WOODLAND PARK APARTMENTS

3670 WOODLAND PARK AVE NORTH
SEATTLE, WA 98103

DESIGN REVIEW

11.11.2025

CONTEXT ANALYSIS

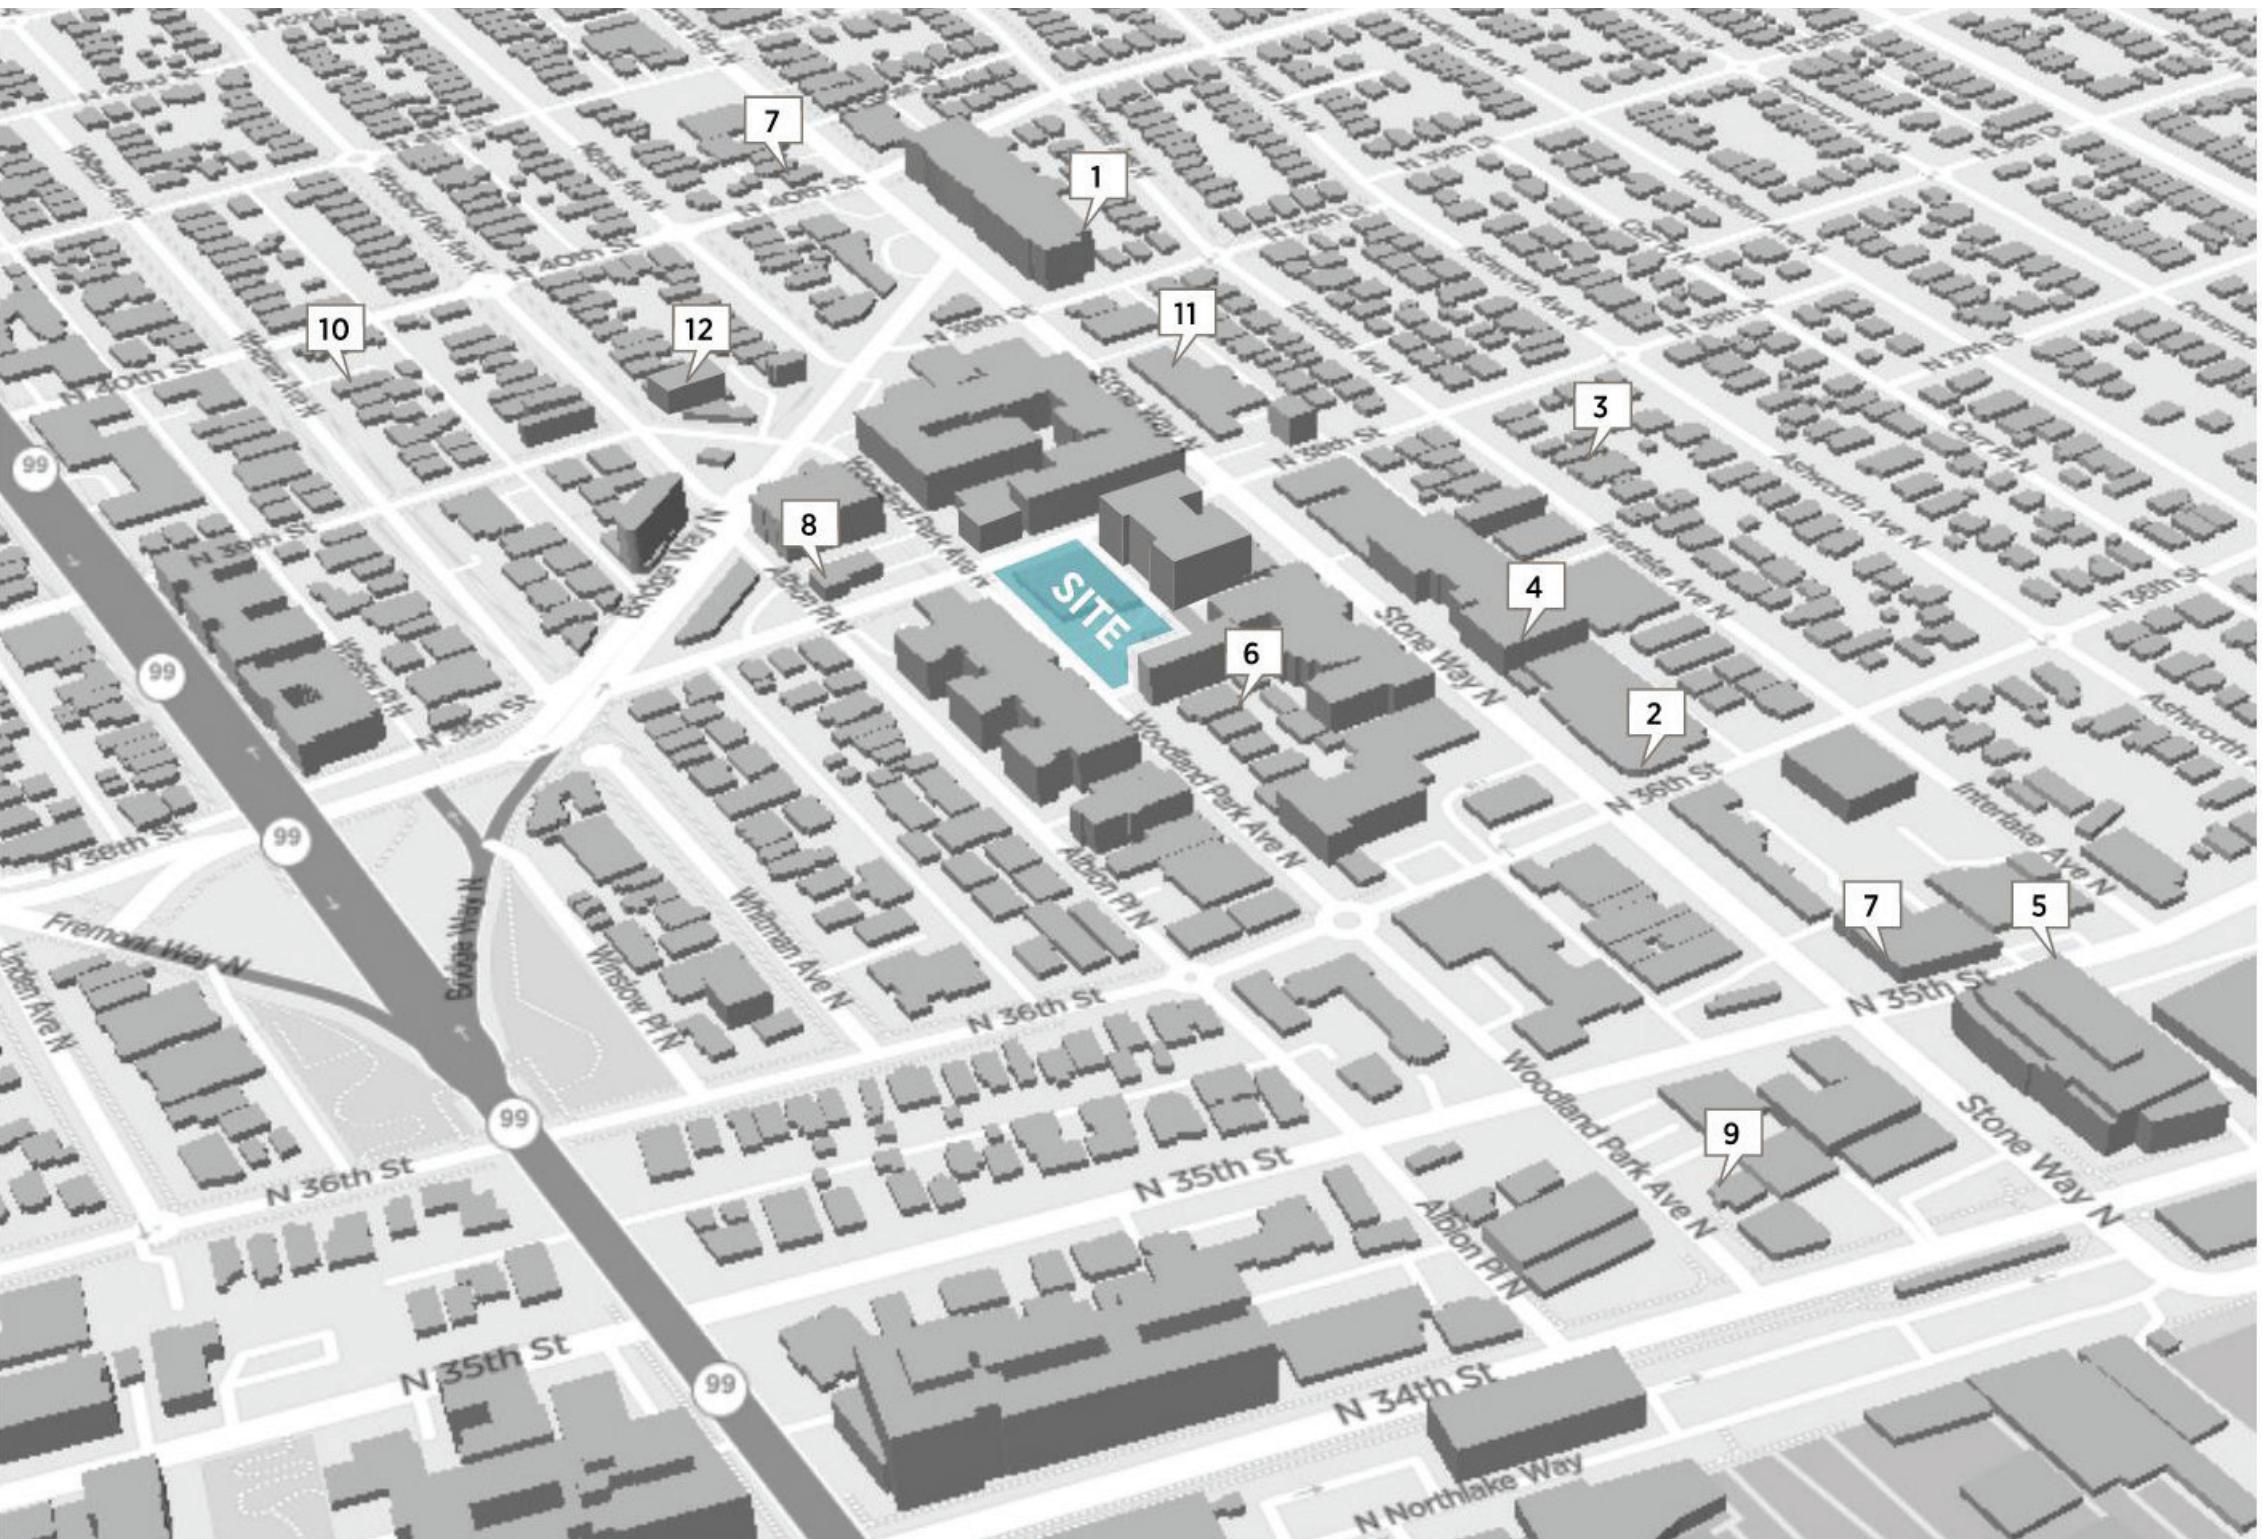
a. The Board expressed appreciation for the context analysis provided in the packet, including that for the Landmarked Shannon and Wilson Office Building, but echoed public comment concerning the limited breadth of included structures. For the next review, the Board provided direction to widen the scope of this analysis, including the existing smaller-scale structures identified by the public nearby and those directly to the south, west, north. The Board also requested at the next EDG meeting, that the applicant's materials include sections cut through the proposal and the adjacent structures and streets and include adjacent context in massing models and renderings.

The design team has incorporated more of the smaller-scale structures and diverse uses that surround the project site in the context analysis. Site sections are included to provide an in-depth context analysis of the adjacent structures in relation to the proposed structure.
